**RE: TransAlta Rail Upgrade
Request for Waivers
CDG Project No. 05002-01**

TRANSALTA - CENTRALIA PLANT
RAIL FACILITIES UPGRADE
PLAN AND PROFILE
STA 16+50 THRU 22+00

SUBJECT: Design Variances and Exceptions

Ash Loadout Facilities, Sta. 21+70.07 foreground; Sta. 20+69.88 background.

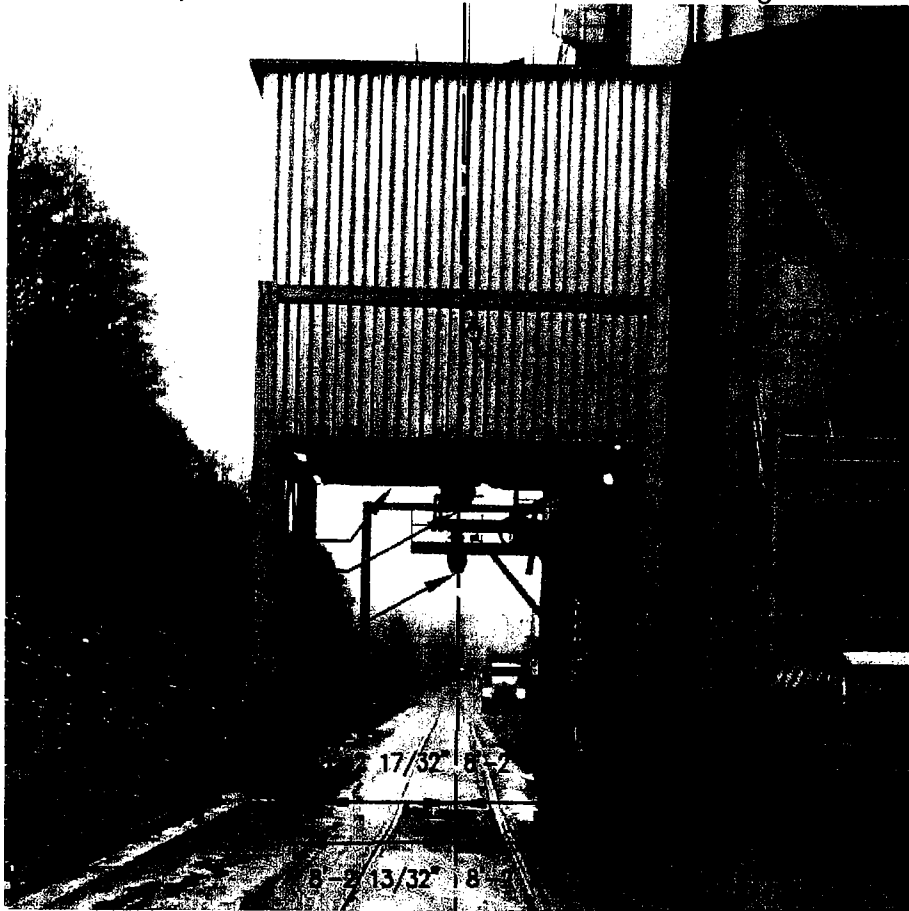
The structures in the center of the photograph below illustrate the ash loading facilities. In the foreground is the enclosure and chute at Sta. 21+70.07. As the train enters the enclosure at Sta. 21+56.54, the lower edge of the enclosure, having a clearance of 17'-8 7/8" does not meet the 18'-00" required by the State of Washington for a train traveling through a building, thus a waiver will be required. Increasing the clearance would require replacing the structure at significant cost.

The horizontal clearance required by the State of Washington when in buildings is 8'-6". There are four footings which encroach on this requirement. At Sta. 21+57.48, the horizontal clearance is 8'-2 7/8" Left (picture right) and 8'-2 17/32" Right (picture left), and at Sta. 21+81.96, horizontal clearance is limited to 8'-3 15/32" Left (picture right) and 8'-2 13/32" Right (picture left). These foundations support the enclosure around the primary ash loadout facility. Adjustment to these footings would require replacing the enclosure at significant cost. A variance will be required due to the narrow width between foundations.

The clearance under the primary loading chute at Sta. 21+07.07 is 15'-8 7/8". Again using the BNSF Locomotive Clearance Diagram (Dwg. No. 903024B) as a reference, 16'-1 15/16" is needed to clear the locomotive. The Plant is able to adjust the chute, increasing the clearance to 17'-0", sufficient to clear the locomotive, but still requiring a waiver. Adjusting the loadout to meet the State minimum requirement would require reconfiguration of the entire loadout structure.

PROJECT NO. **05002**
 DRAWING NO. **C-102**

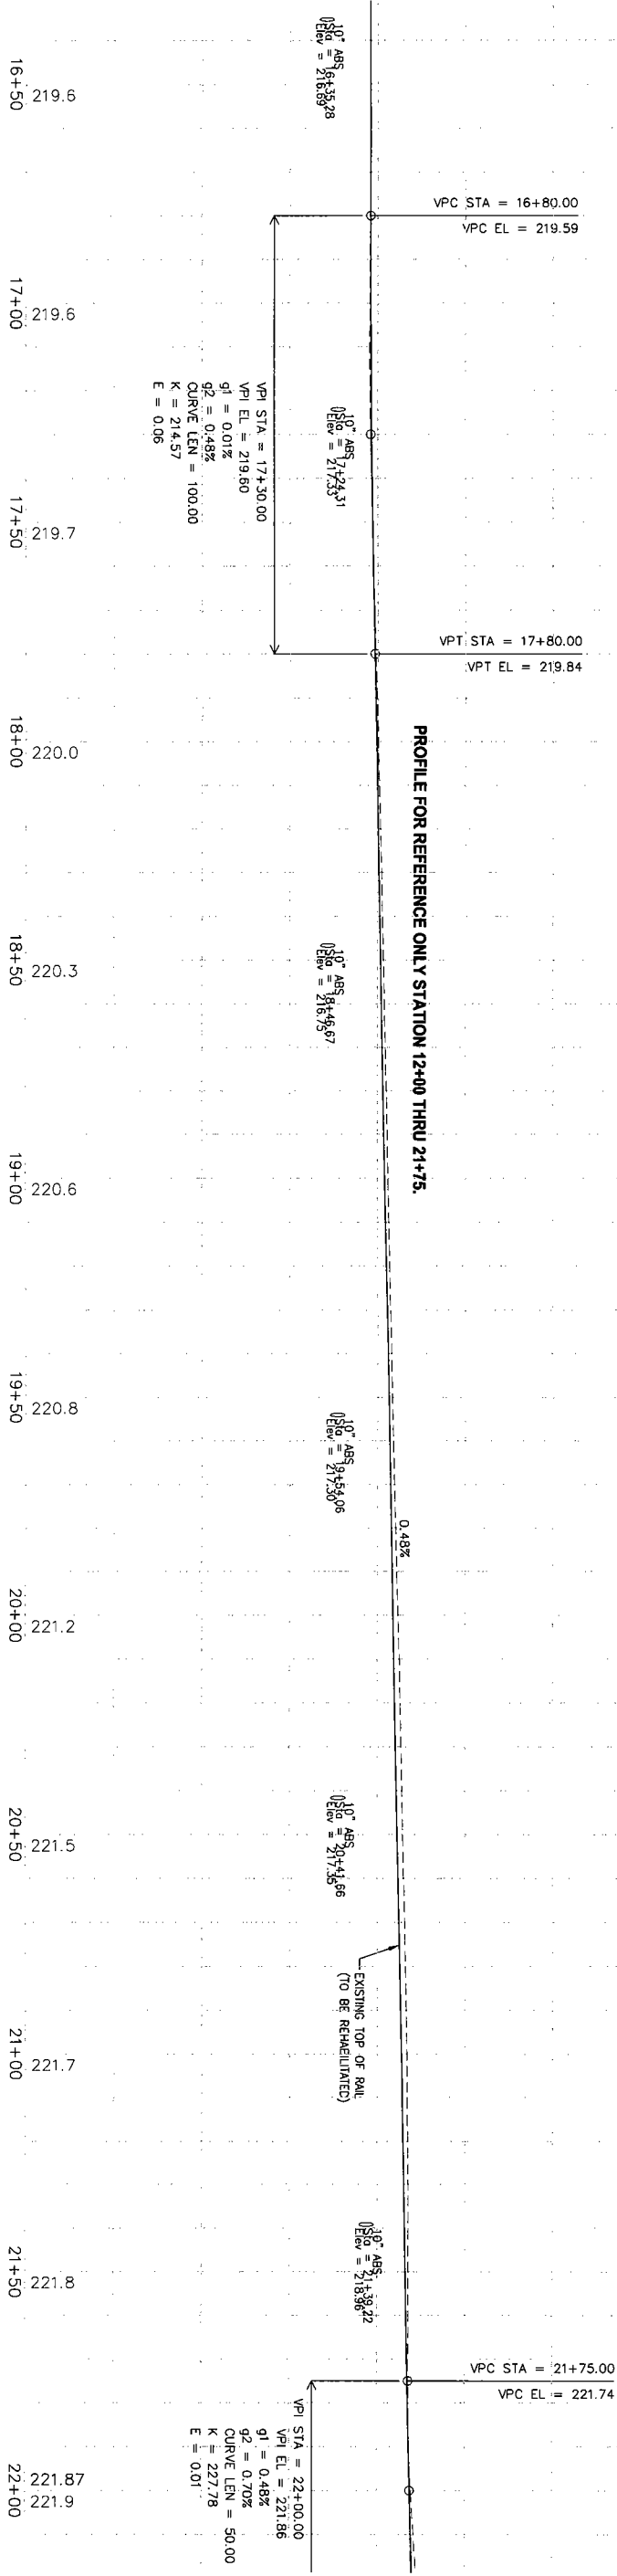
2. Primary Ash Loadout
Sta. 21+56.54: Vertical clearance 17'-8 17/32"

Sta. 21+57.48: Horizontal clearance 8'-2 7/8" Left, 8'-2 17/32" Right

Sta. 21+70.07: Vertical clearance 16'-3"

Sta. 21+81.96: Horizontal clearance 8'-3 15/32" Left, 8'-2 13/32" Right

BNSF Railway standards require 23'0" vertical clearance and Washington Statutory Regulation Chapter 480-60 requires 22'6" vertical clearance for tracks running through a structure. If owner obtains a variance from the state, BNSF can accept this fixed vertical clearance at this location. This restriction shall be accompanied by appropriate signage placed at both approaches to the area warning of limited clearances as required by state statute and BNSF Railway operating rules.

BNSF Railway standards and Washington Statutory Regulation Chapter 480-60 requires 8'6" horizontal clearance for tracks running through buildings. If owner obtains a variance from the state, BNSF can accept these fixed horizontal clearances. This restriction shall be accompanied by appropriate signage placed at both approaches to the area warning of limited clearances as required by state statute and BNSF Railway operating rules.

Proposed clearance is not acceptable. BNSF Railway standards require 23'0" vertical clearance and Washington Statutory Regulation Chapter 480-60 calls for 22'6" vertical clearance for tracks running through a structure. If owner obtains a variance from the state, BNSF can accept a fixed vertical clearance no less than 17'0" from top of rail at this location. This restriction shall be accompanied by appropriate signage placed at both approaches to the area warning of limited clearances as required by state statute and BNSF Railway operating rules.

BNSF Railway standards and Washington Statutory Regulation Chapter 480-60 requires 8'6" horizontal clearance for tracks running through buildings. If owner obtains a variance from the state, BNSF can accept these fixed horizontal clearances. This restriction shall be accompanied by appropriate signage placed at both approaches to the area warning of limited clearances as required by state statute and BNSF Railway operating rules.

Secondary Ash Loadout

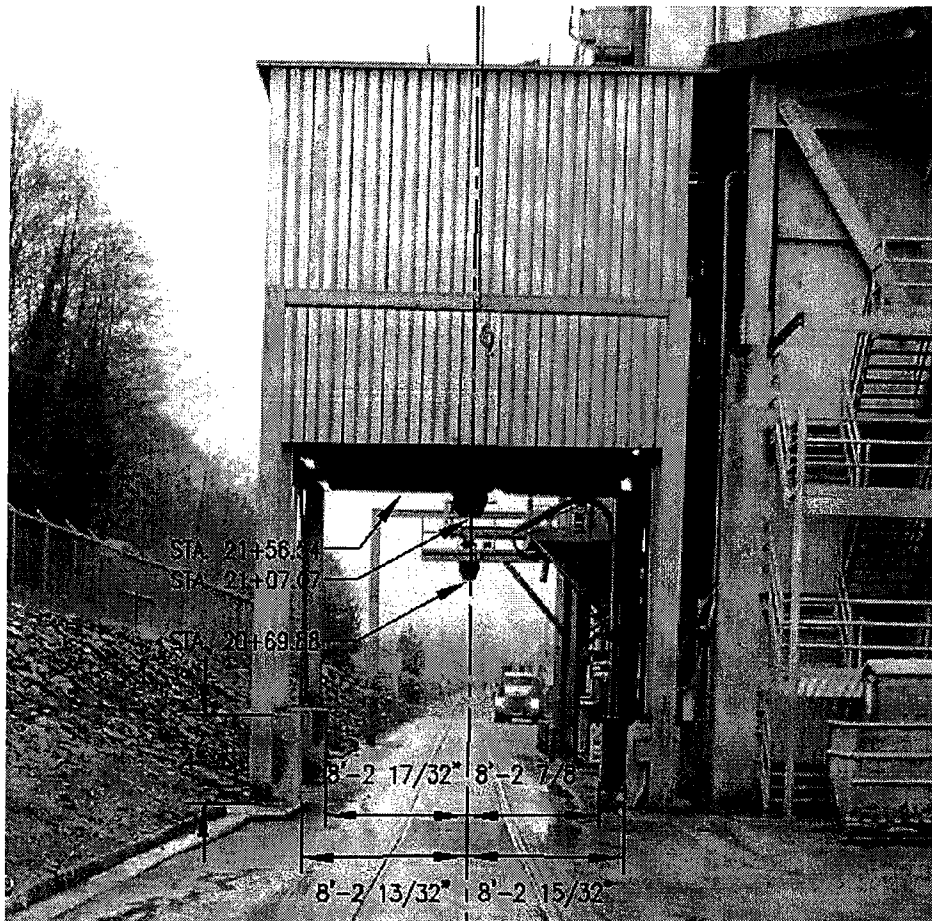
The sketch below illustrates the first of two ash loading facilities existing at the site. The clearance under the secondary loading chute at Sta. 20+69.88 is 15'-10 13/16". Using the BNSF Locomotive Clearance Diagram (Dwg. No. 903024B) as a guide, 16'-1 15/16" is needed to clear the locomotive. The Plant is able to adjust the chute, increasing the clearance to 16'-10", sufficient to clear the locomotive, but still requiring a variance. Adjusting the loadout to meet the minimum requirement would require reconfiguration of the entire structure. The bollards shown in the sketch are for illustrative purposes only and will be removed as part of this project. A concrete barrier, the face of which will not encroach on the minimum clearance requirements, will encase and protect the supports currently protected by the bollards.

Proposed clearance is not acceptable. BNSF Railway standards require 23'0" vertical clearance and Washington Statutory Regulation Chapter 480-60 calls for 22'6" vertical clearance for tracks running through a structure. If owner obtains a variance from the state, BNSF can accept a fixed vertical clearance no less than 17'0" from top of rail at this location. This restriction shall be accompanied by appropriate signage placed at both approaches to the area warning of limited clearances as required by state statute and BNSF Railway operating rules.
